*Seattle
Bicycle
Advisory
Board*

6 April 2007

Subject: Stone Way North Update (29 March 2007)

Stone Way North Update; March 29, 2007

Stone Way South of 40th Street

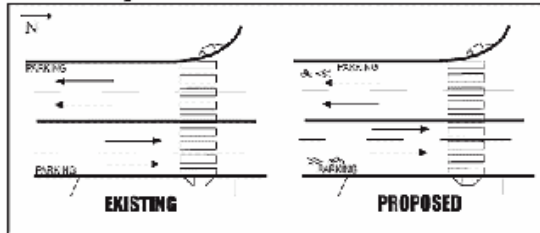
The Seattle Bicycle Advisory Board (SBAB) was surprised by and is strongly opposed to the revised proposal for Stone Way North announced by the Seattle Department of Transportation (SDOT) on its website on 29 March 2007 (see attachment of the project webpage with highlighted references). This update proposes a three-lane cross-section for motor vehicles, one lane in each direction plus a center turn lane, for the segment of Stone Way North between North 40th and 50th Streets. On this segment, SDOT now proposes a northbound (uphill) bicycle climbing lane but only shared pavement markings ('sharrows') in the southbound direction. For the segment between North 34th and 40th Streets, there would remain four motor vehicle lanes, two in each direction, and only 'sharrows' would be added for bicyclists in both directions. Two curbside parking lanes would remain for both segments. A crosswalk will be removed at N 38th Street.

We recommend the city adopt a three-lane cross-section for motor vehicles, one lane in each direction plus a center turn lane, including full bicycle lane facilities in both directions, for the entire length of Stone Way North from North 34th to 50th Streets.

On the section of Stone Way N between N 34th Street and N 40th Street, SDOT will be **maintaining four motor vehicle lanes** in recognition of the volume of freight along this route. Sharrows will be installed both uphill and downhill to maintain this link in the bicycle network. The marked crosswalk at N 38th Street will be removed.
